M24C32S-FCU package mechanical data modifications

This errata sheet applies to the M24C32S-FCU, that is the 32Kbit serial I²C bus EEPROM delivered in WLCSP four balls.

Figure 2. D and E front side view

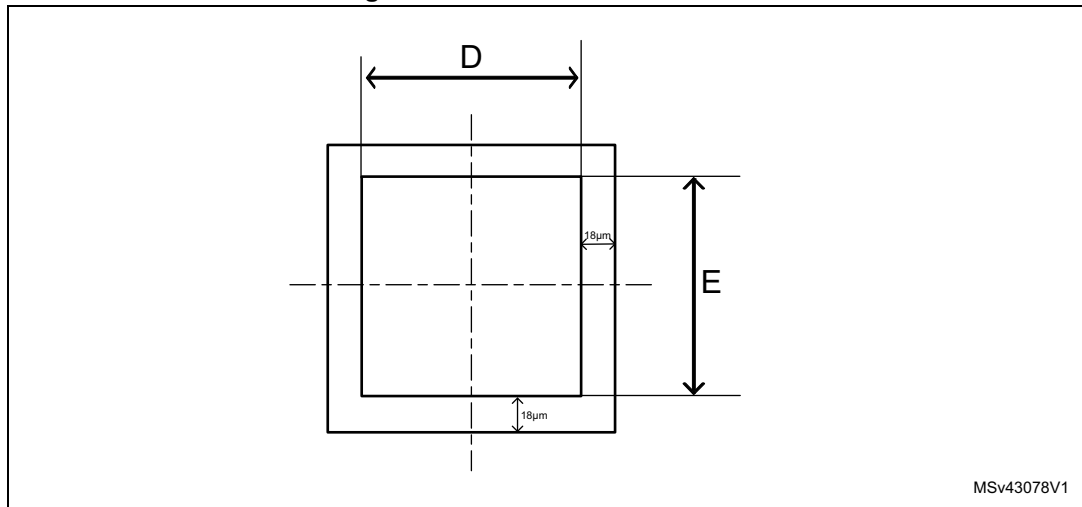
- The D and E values on M24C32S-FCU datasheet corresponding to front side view (ball side) as shown in [Table 2](#), instead of back side view (marking side view) as shown in [Table 3](#).

Symbol	Millimeters			Inches		
	Min	Typ	Max	Min	Typ	Max
D	-	0.833	0.853	-	0.0328	0.0336
E	-	0.833	0.853	-	0.0328	0.0336

Figure 3. D and E back side view

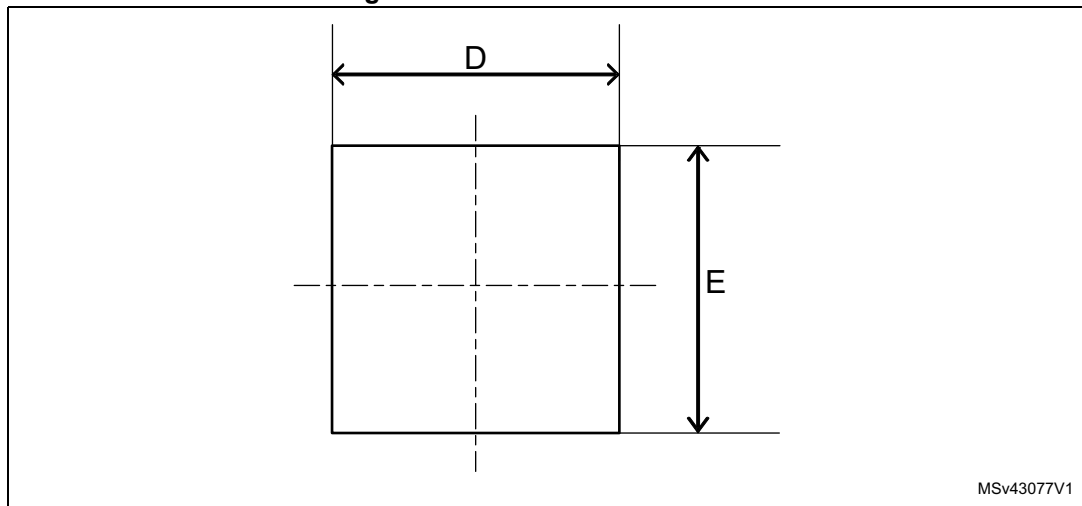
This document refers to the changes of dimensions D and E (see [Figure 3](#)) described in the M24C32S-FCU datasheet, in tables detailing the dimensions of the Ultra Thin WLCSP 4-bump package.

D and E values must be modified to correct the following mistake:

Symbol	Millimeters			Inches		
	Min	Typ	Max	Min	Typ	Max
D	0.831	0.851	0.871	0.0327	0.0335	0.0343
E	0.831	0.851	0.871	0.0327	0.0335	0.0343

Figure 4. D or E side view

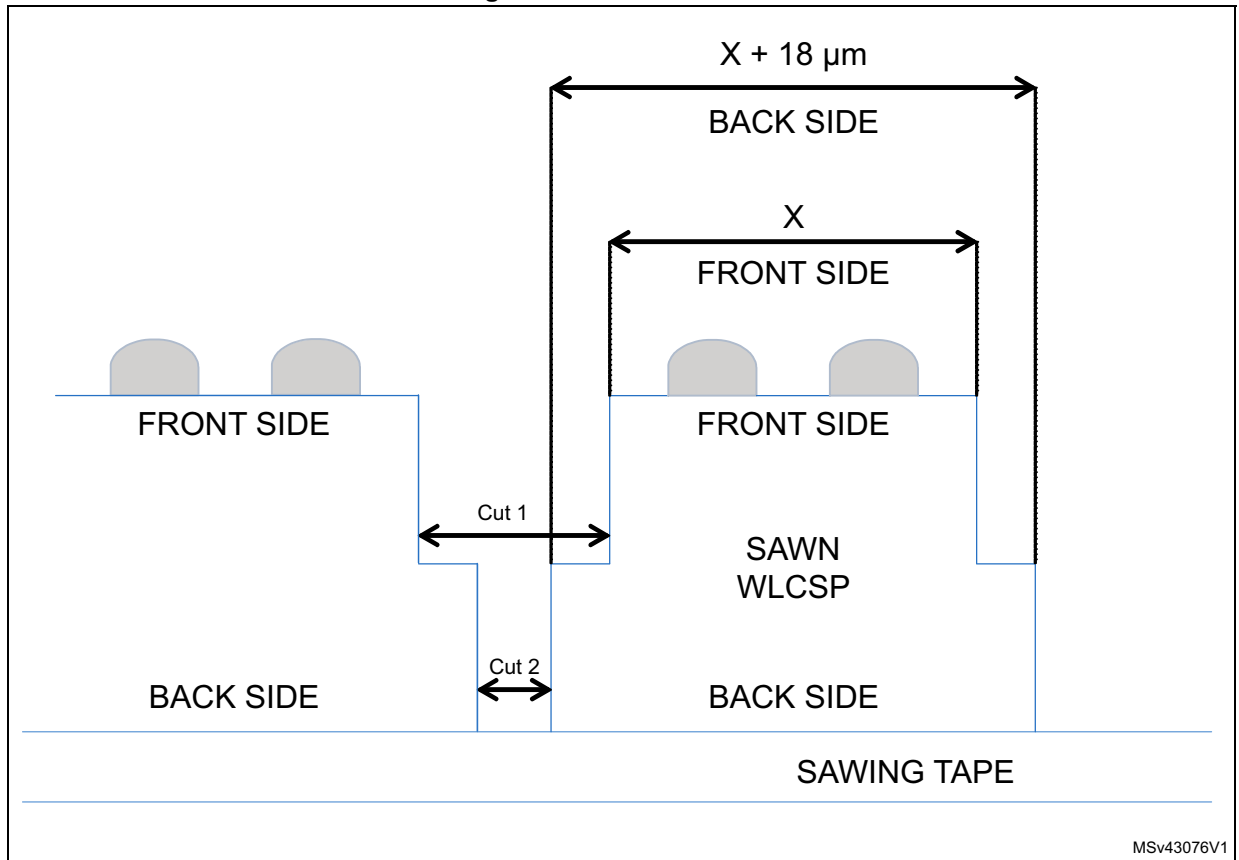
The difference between back side and front side dimension is 18 μm (0.018 mm). This difference is due to two-step sawing process, where cut 1 and cut 2 are performed with blades having different thickness (see [Figure 4](#) in which X represents D or E and it has the same value and tolerance).
